Re: Agnico Eagle Mines – Meadowbank Division Responses to North East Dike Design Report Comments

- CIRNAC – August 21, 2018, *Crown-Indigenous Relations and Northern Affairs Canada (CIRNAC) Technical Review Comments of the Design Report For the North East Dike – Whale Tail Project under Agnico Eagle Mines Limited's Type "A" Water Licence No. 2AM-WTP1826.*

Mine Layout Watersheds – Phase 1

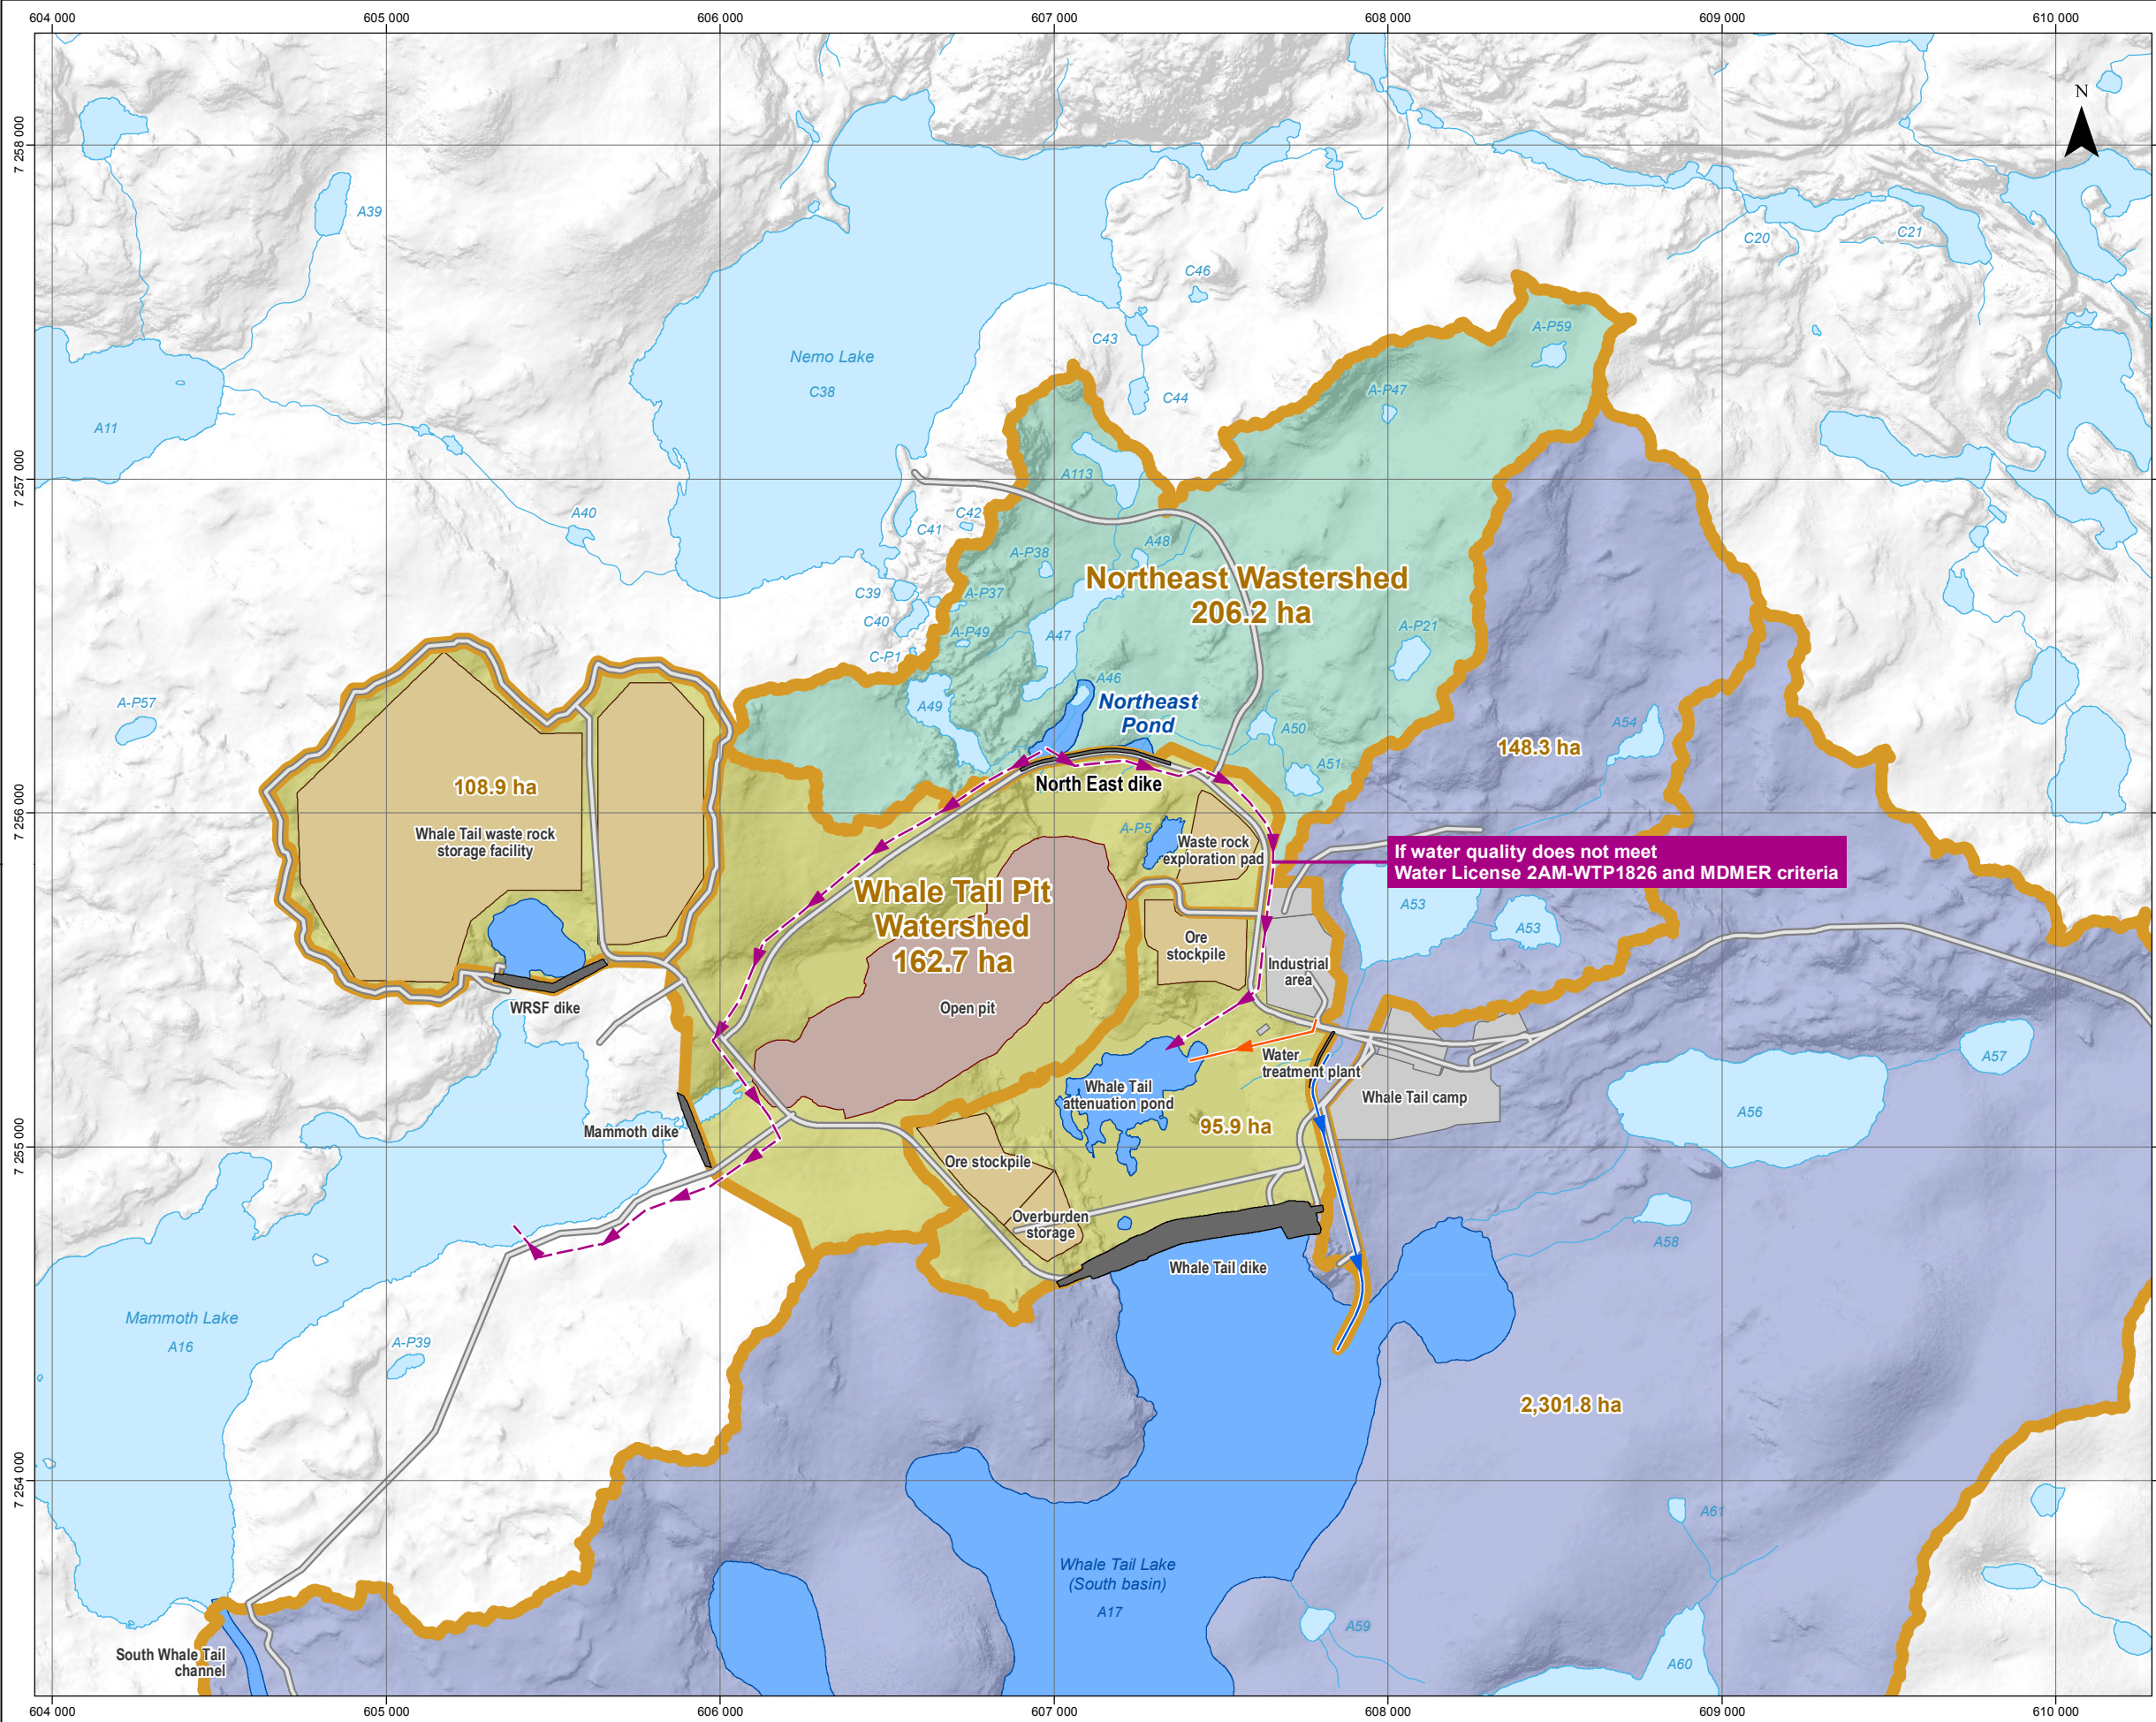
The report describes how the dike will direct flow, however CIRNAC has uncovered inconsistencies. Section 1.2 of the report states “water from the pond that will be created on the upstream side of the dike will be periodically pumped out and treated for suspended solids at the Attenuation Pond.” The area of this pond is not depicted in the report.

Section 4.3 NE Pond Operational Criterion states “in case of a flood larger than the design flood, water will overflow towards Nemo Lake rather than towards the mine site”. There are two issues here. First, where is the NE Pond located? CIRNAC assumes this is the same pond mentioned in Section 1.2 without a name. CIRNAC therefore recommends attaching a detailed map with the size and location of this pond with this report.

Section 5.1.3 of the report states “the NE Dike collects a watershed of approximately 206 ha as shown on Figure 5-2. It will be used to store runoff water from this watershed, to stop it from flowing towards the mine site and pit, before it can be pumped towards Mammoth Lake.” In this section, the report indicates that the water will be pumped toward Mammoth Lake. Earlier in the report, it’s stated that water would be pumped to the attenuation pond. CIRNAC recommends that the applicant provide clarification.

In summary, CIRNAC recommends that the applicant provide a more detailed map depicting flow direction, the location of the NE Pond, and direction of pumping. Supplemental information shall also clarify where the water will be pumped from/to, as well as at what water elevation will the water flow towards Nemo lake instead of being pumped to the Attenuation Pond.

To provide clarification, Figure 5.2 has been updated below to show the location of the NE Pond and direction of pumping. Water from the NE Pond will be discharged to Mammoth Lake unless water quality does not meet Water License 2AM-WTP1826 and MDMER criteria. If water quality does not meet above criteria, it will be pumped to Whale Tail Attenuation Pond.

Water from Northeast pond is sent to Whale Tail attenuation pond if its quality does not mee the discharge criteria.
